**SIDEWALK WAIVER REQUEST  
STAFF REPORT****Date: June 21, 2007**

Alabama Power Company

**LOCATION**249 Yeend Street  
(South side of Yeend Street, 700'± East of South Lawrence Street).**PRESENT ZONING**

## SITE PLAN

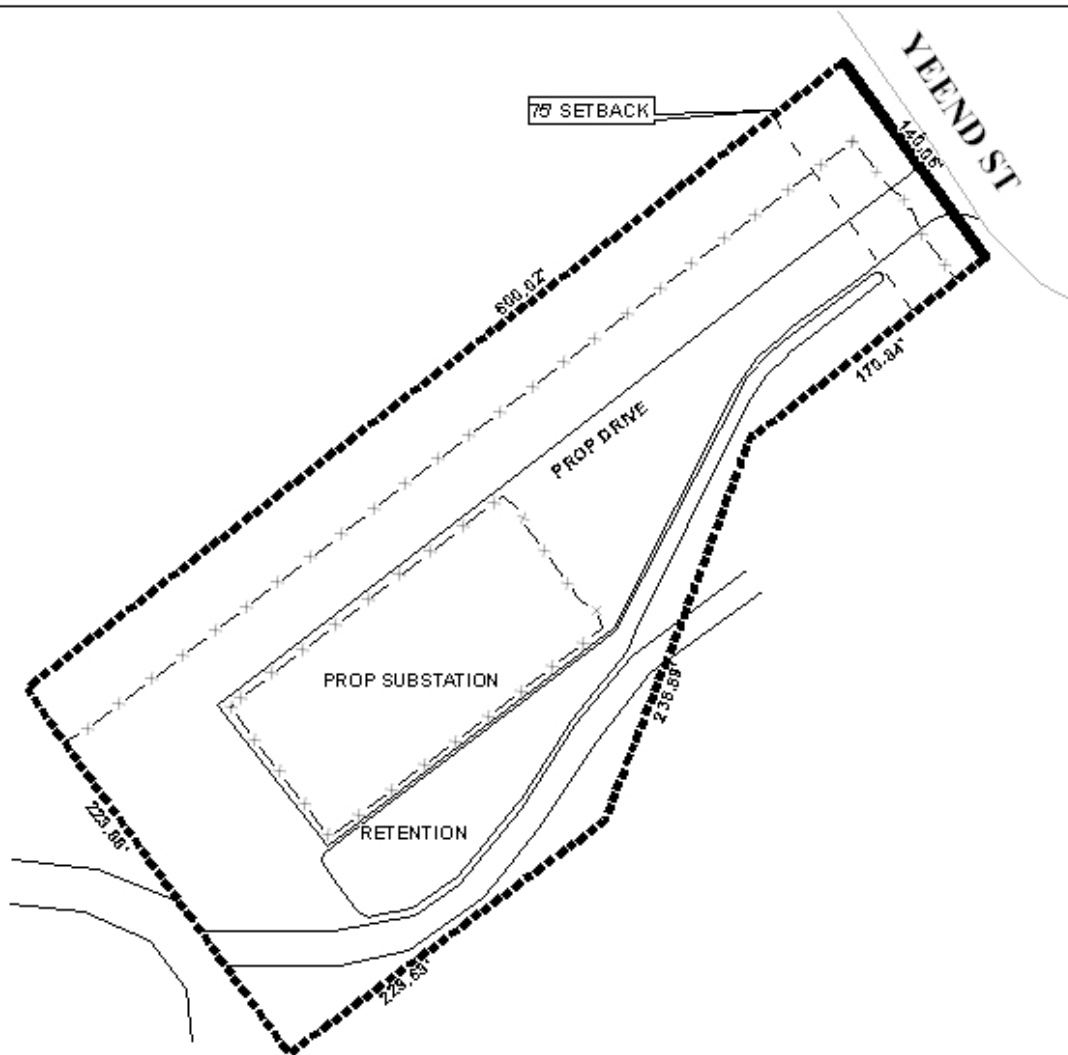
Provide additional information, i.e. a cross section depicting the area waiver requested in.

City of Mobile Engineering has requested more information for this application, specifically, a cross-section of the area where the sidewalk waiver is requested. The information provided depicted several cross sections, but none of them were in the area applicable to this application.

Based on the preceding, this sidewalk waiver request is recommended for holdover until August 2, 2007, meeting, with 3 copies of the cross sections in the area where the sidewalk waiver is being requested (i.e. the right-of-way) to be submitted to the Planning Section of Urban Development by noon on July 9, 2007.
